Extension and Alterations

The Barn, Preston Road,
Alston. PR3 3BL

Planning Application
Proposed Ground Floor Plan

JOB NO 3441
DRAWING NO 102
REVISION A
SCALE 1 : 100 @ A3

Ground Floor Plan
1 : 100

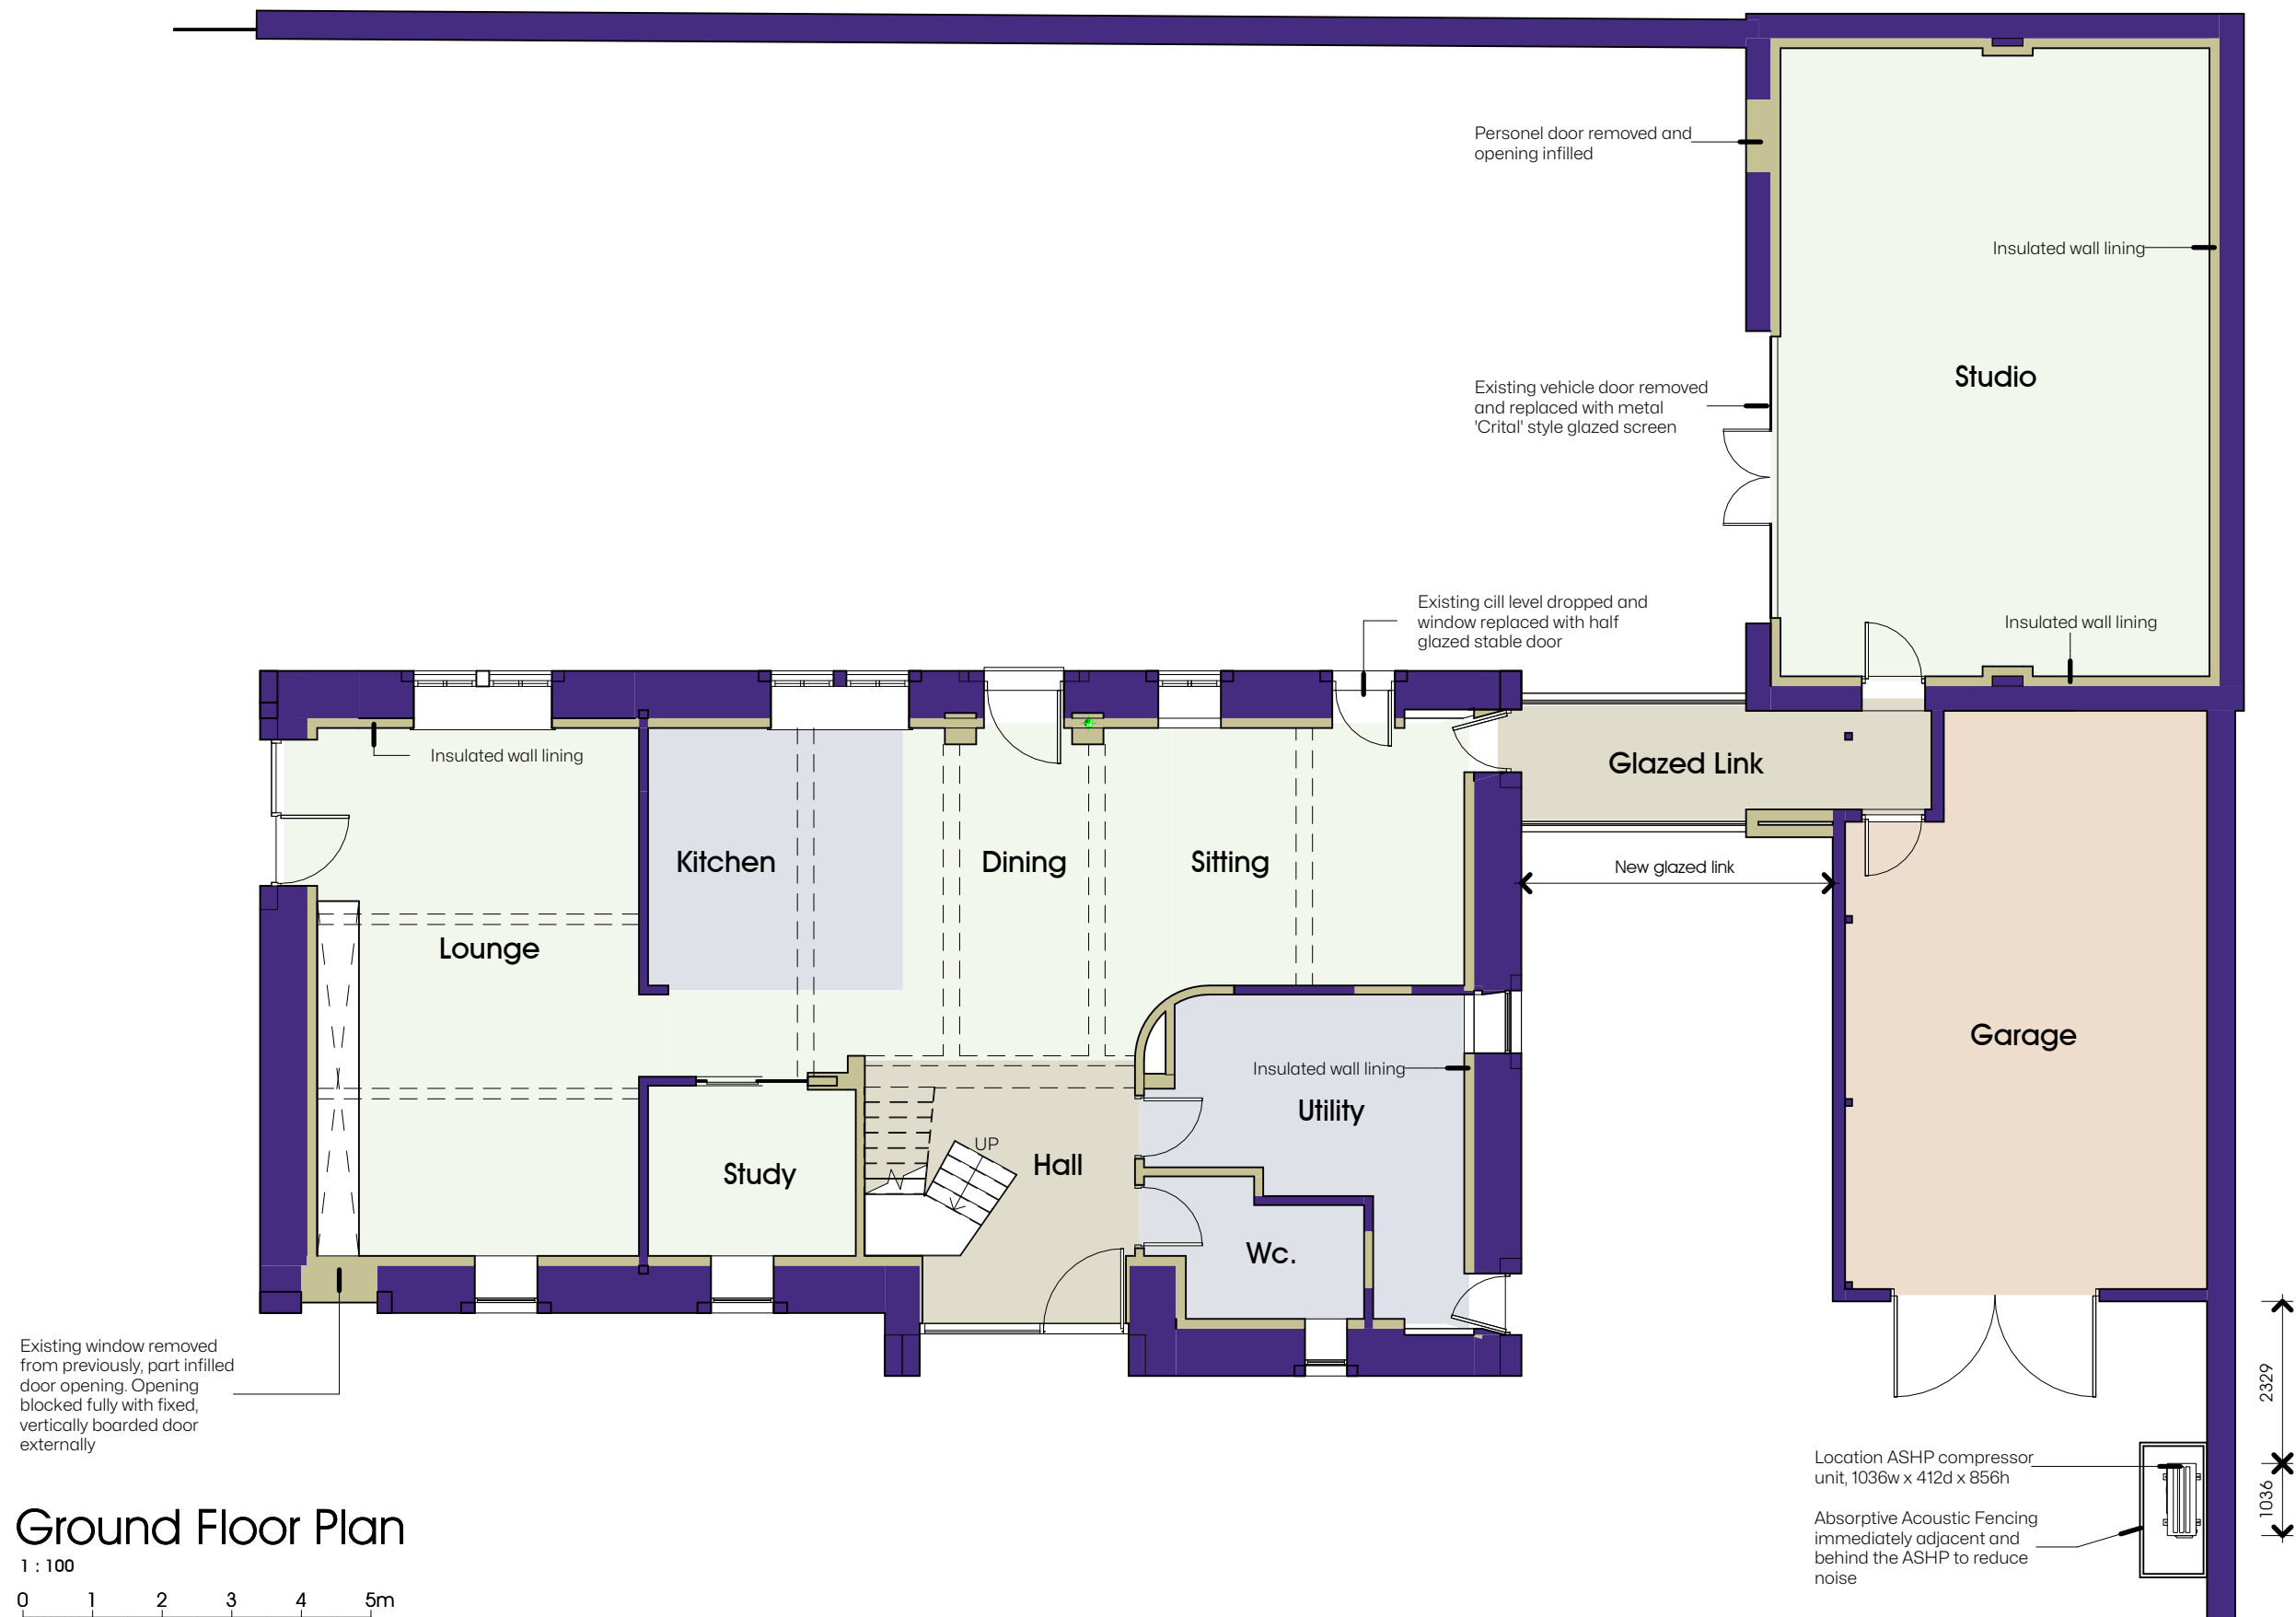
A 17-07-2025 Acoustic fence shown to ASHP. Cladding removed.
